TREEHOUSE AMENITY CENTER
RFI LOG

The following RFI questions have been submitted for the Treehouse Amenity Center bid request:

THE COLONY - TREEHOUSE AMENITY CENTER

Sheet No.
LPN - 1.0 _____ of _____

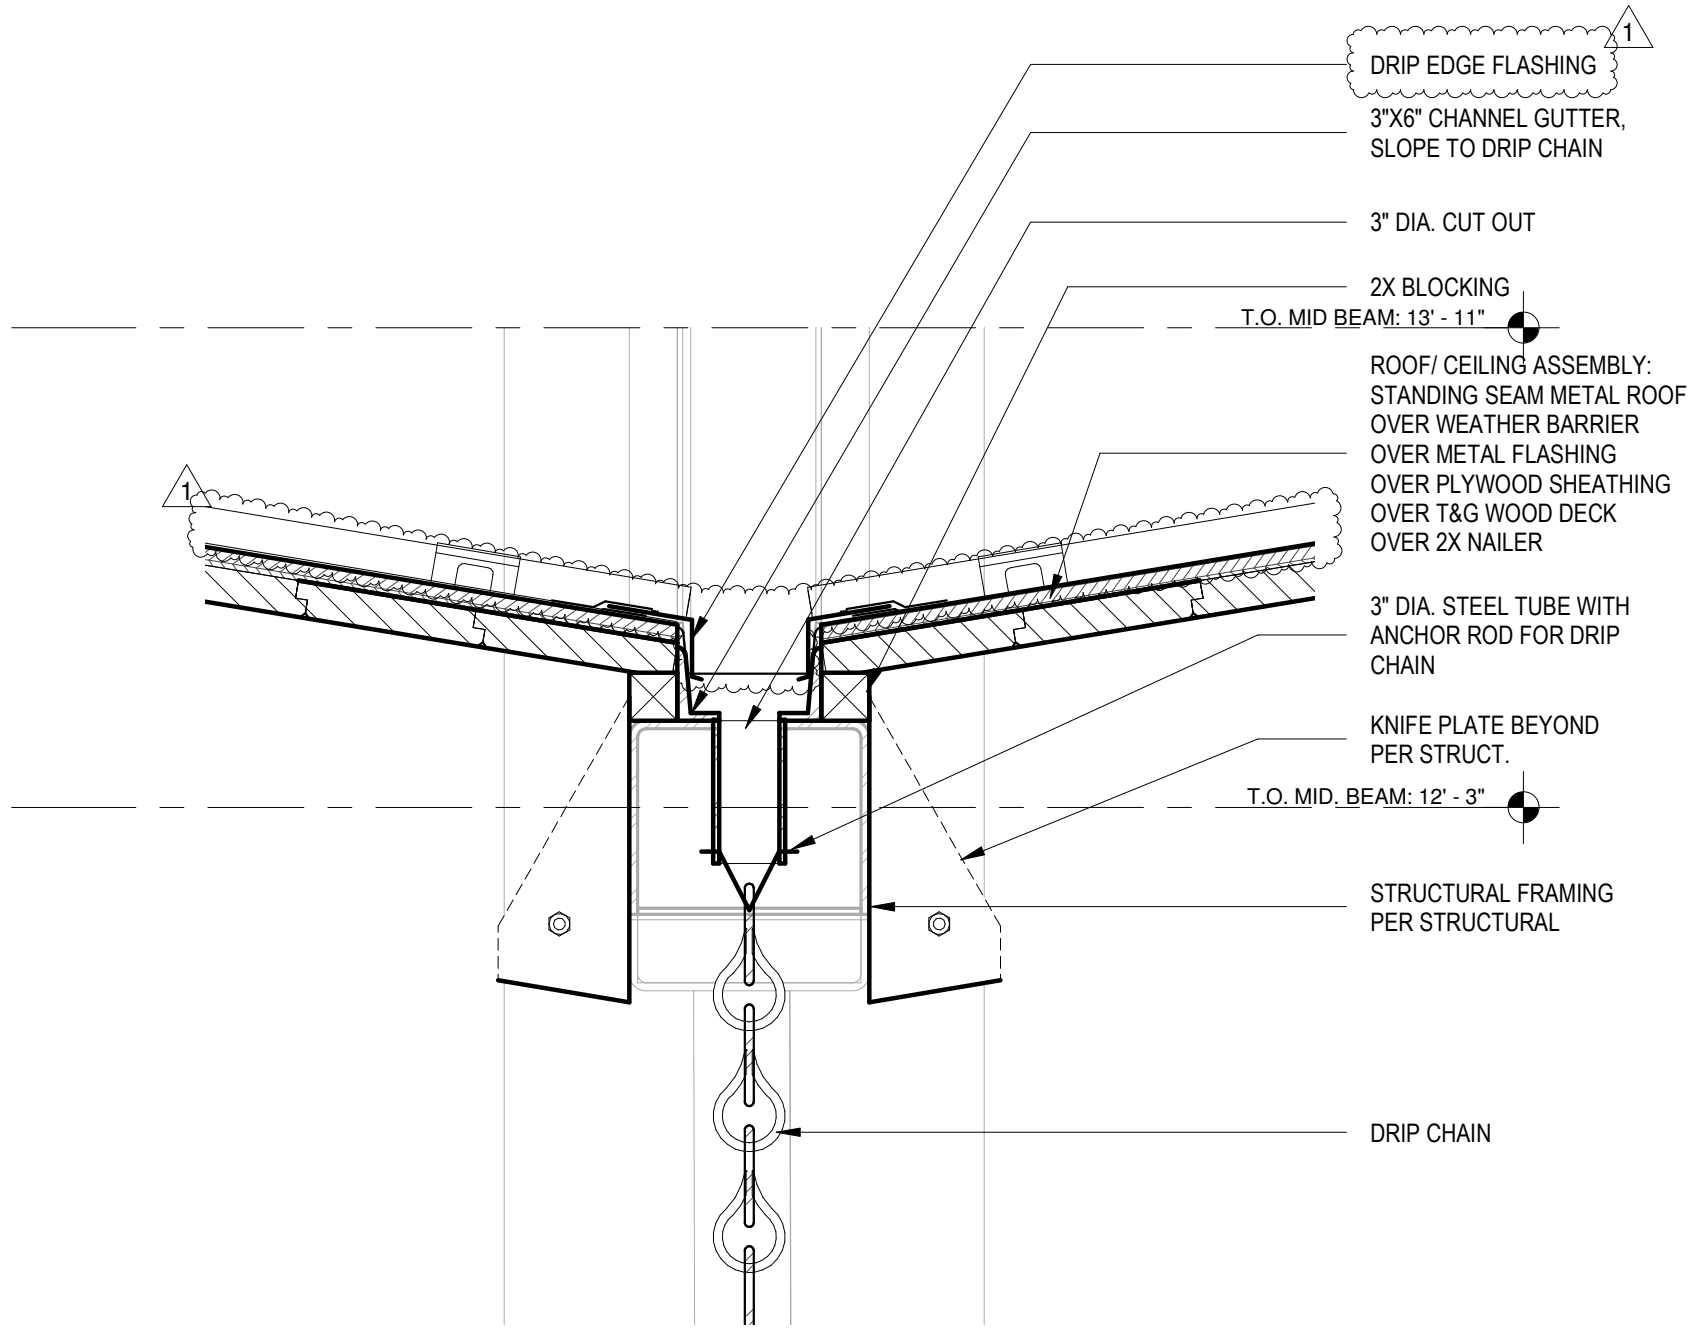
Q.) The seed areas on the plan do not match the quantities in table on LPN-1.0

Q.) There is decomposed granite shown on the material table on LPN-1.0 but not on the plans?

Q.) Plant soils are called out as “Per notes and Specifications” though we can’t find the specs?

A.) The plant material table quantities have been updated.

A.) The plant material table has been updated to remove the decomposed granite.

A.) The plant material table has been updated to include soil specs.

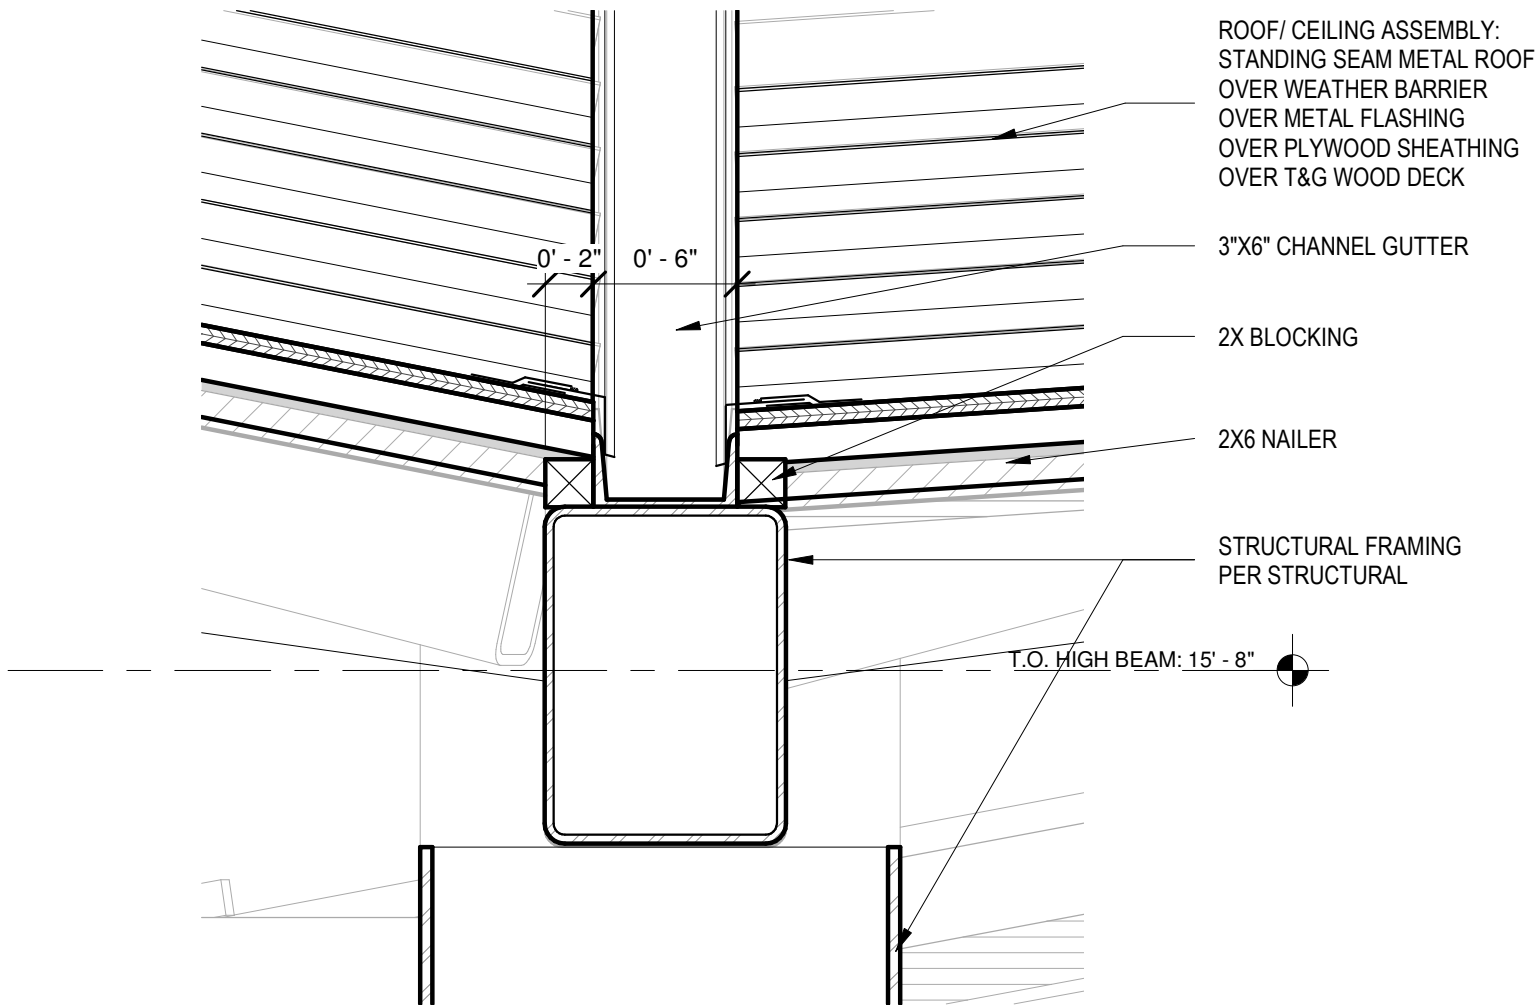
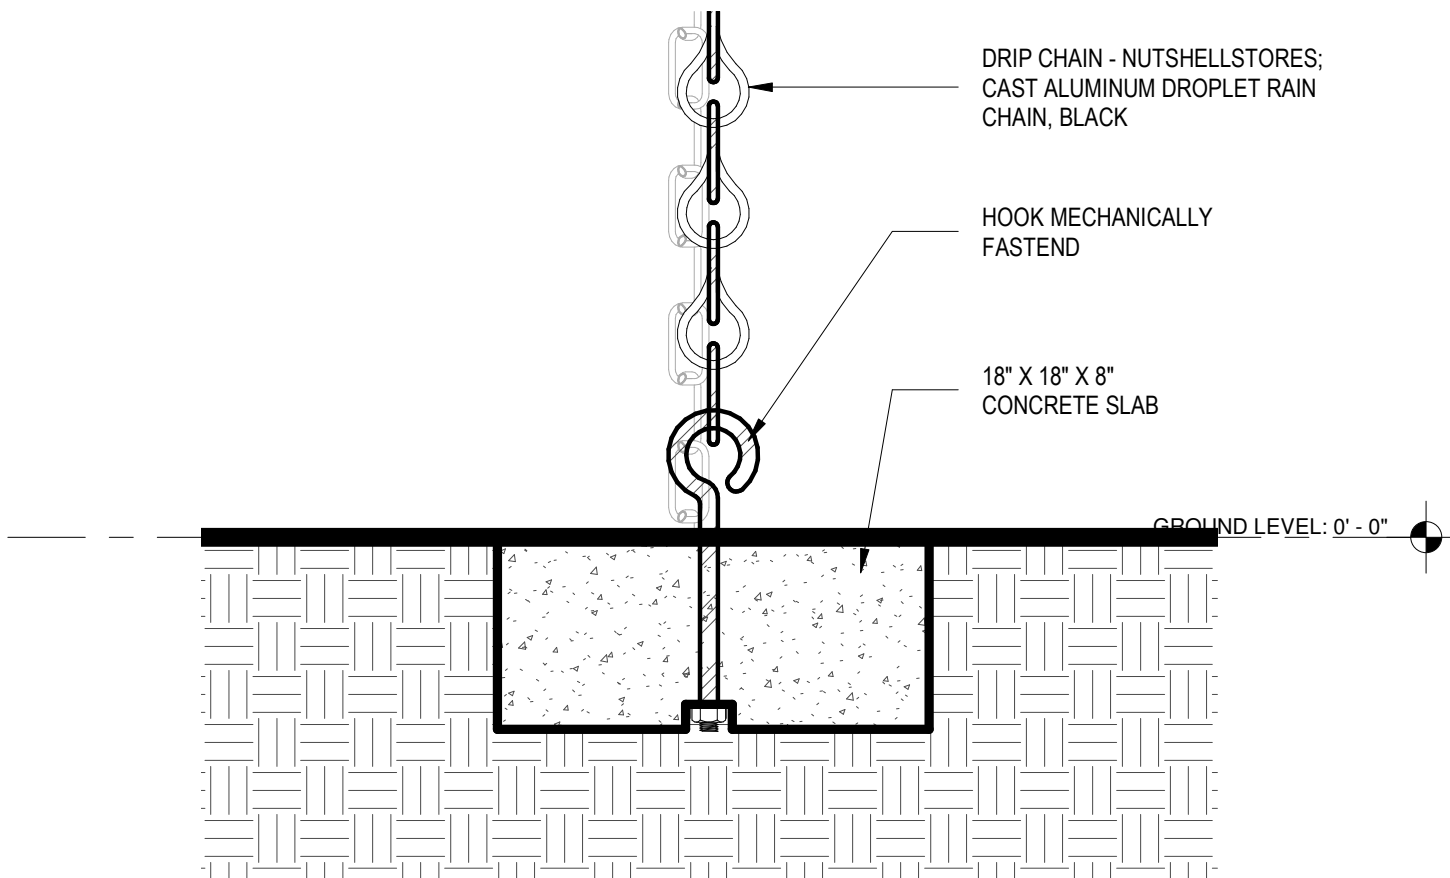
Q.) The “D” style flashing extends out past the fascia 1” to drain and will close the gutter opening from 6” to 4”. The detail shown seems to be the application for a TPO roof assembly.

A.) Detail for drip edge flashing has been updated. Standing seam roof now shown and drip edge detail called out.

A-101

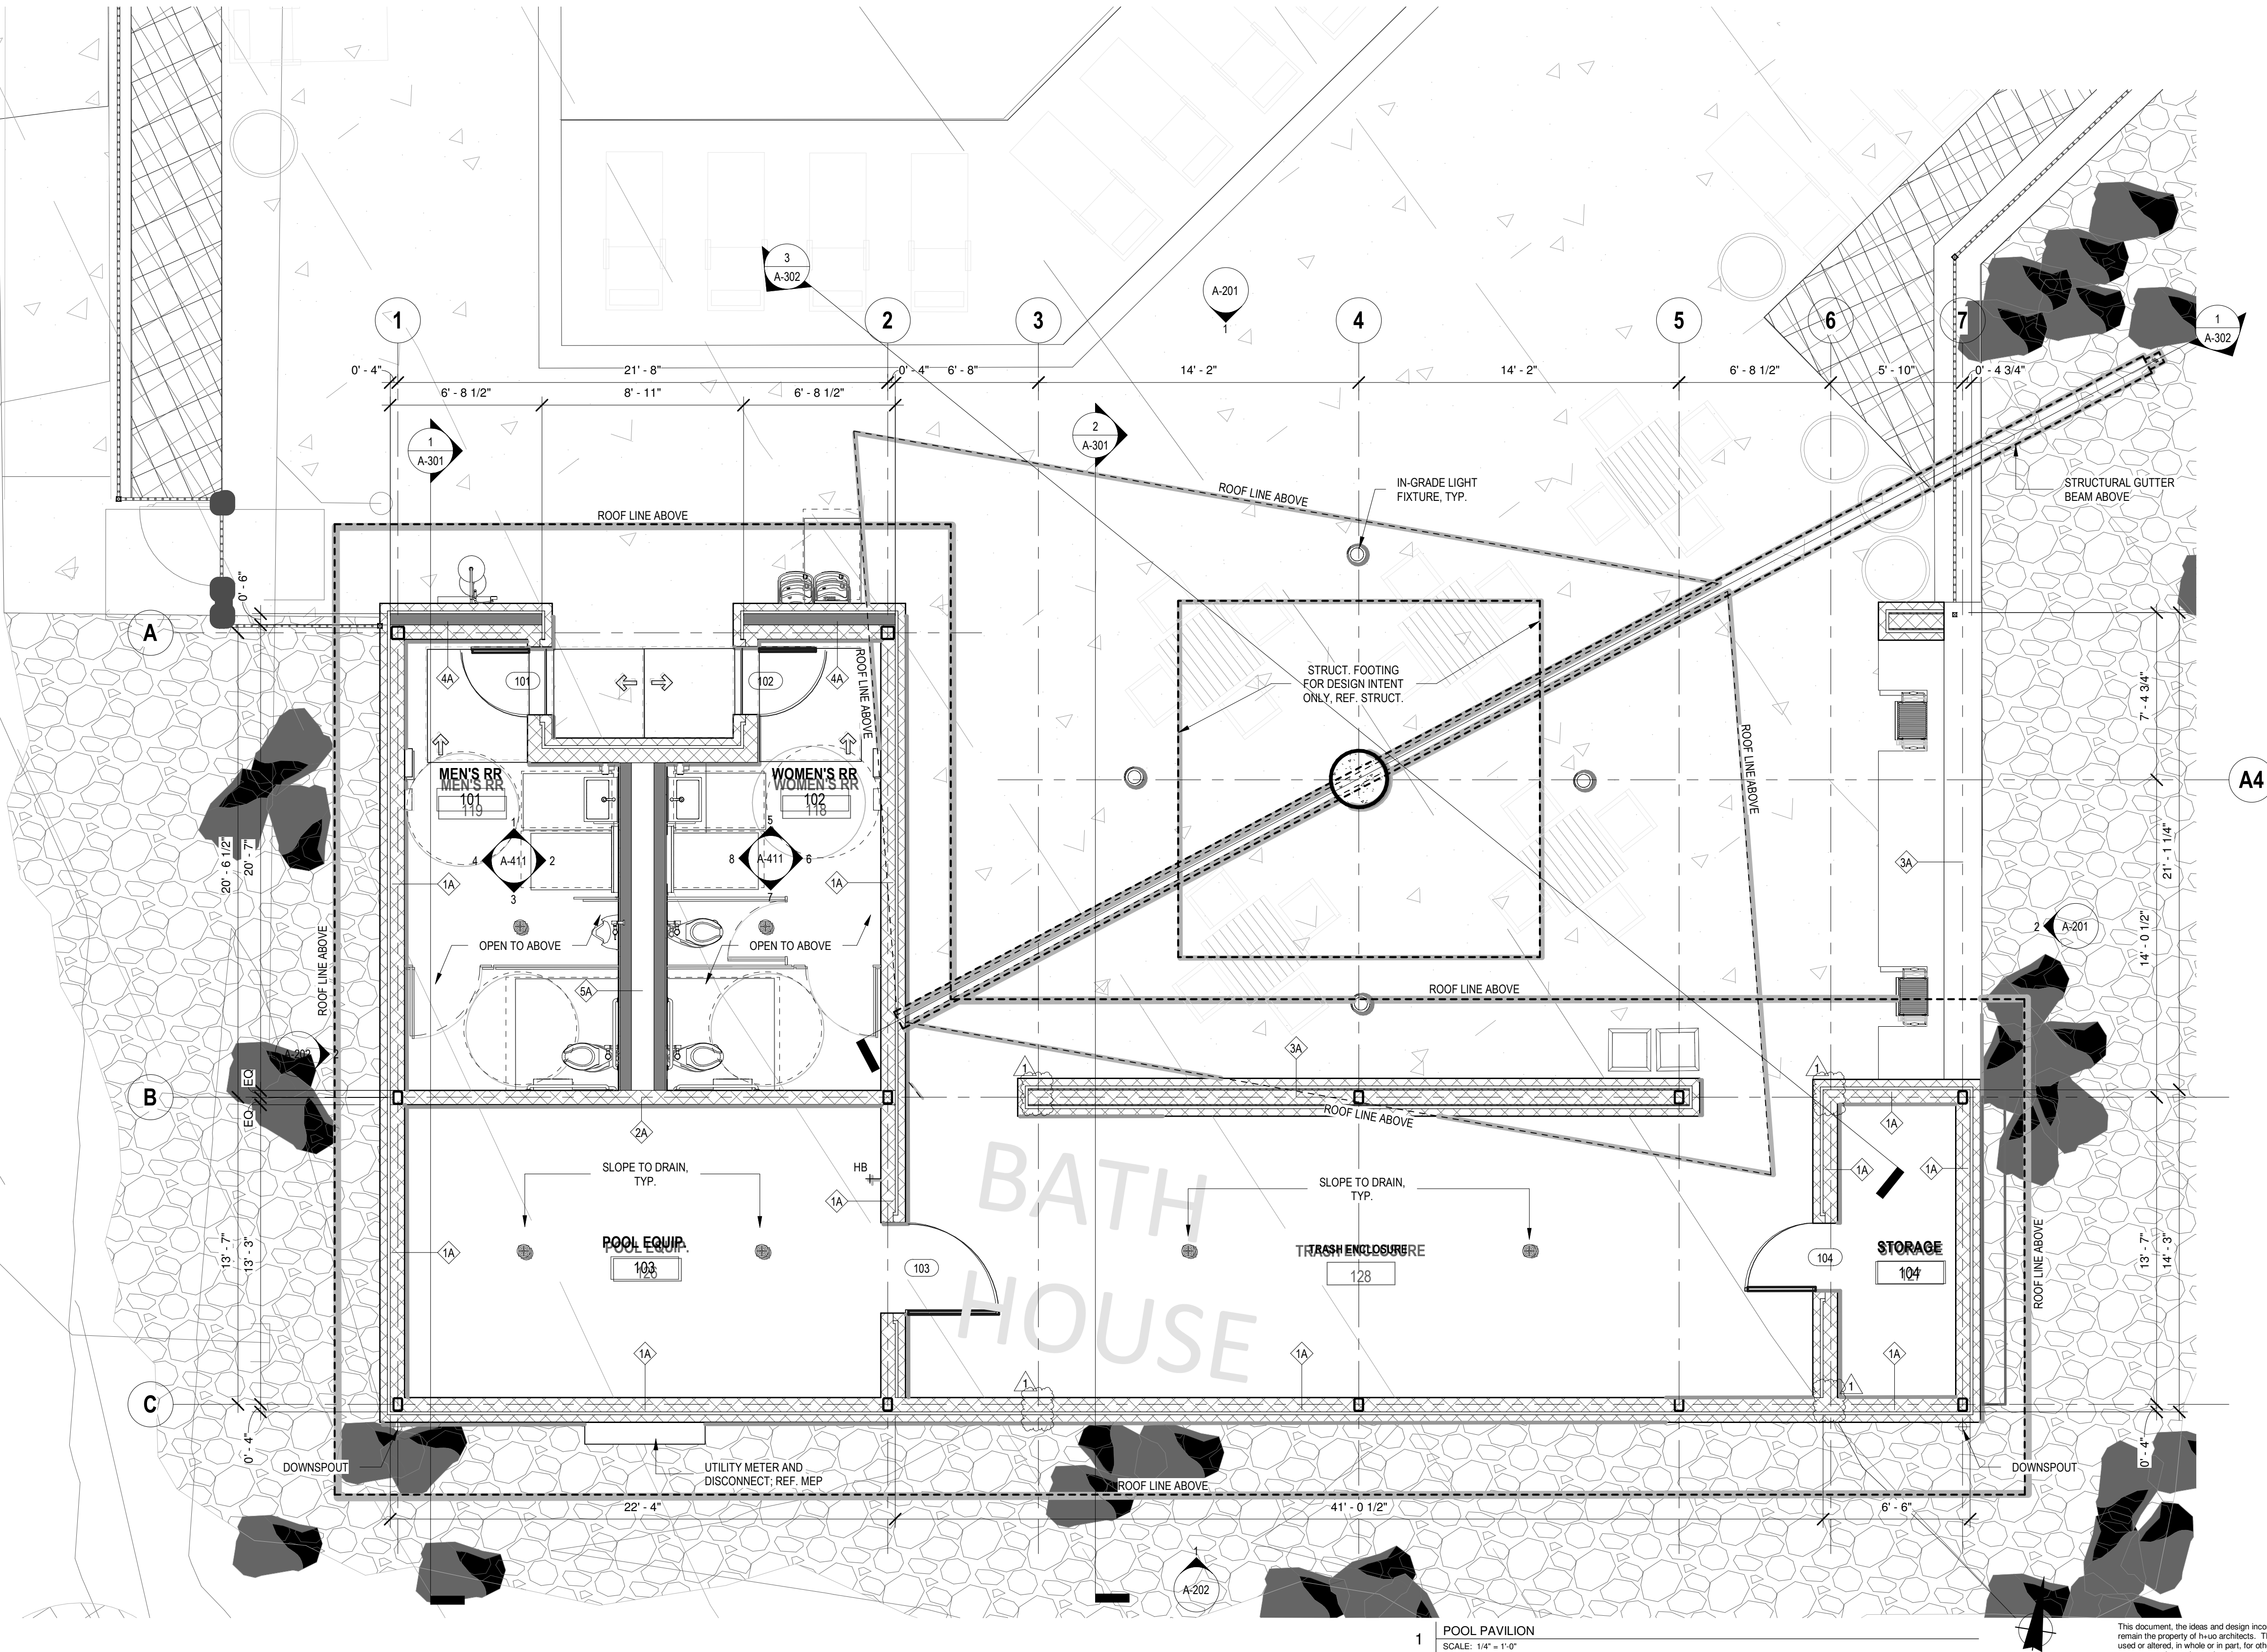
Q.) HSS 7x5x1/2 @ Pool building on Arch plans but not structural

A.) Columns to be removed at grid 3 and 6 – Arch plans to be updated
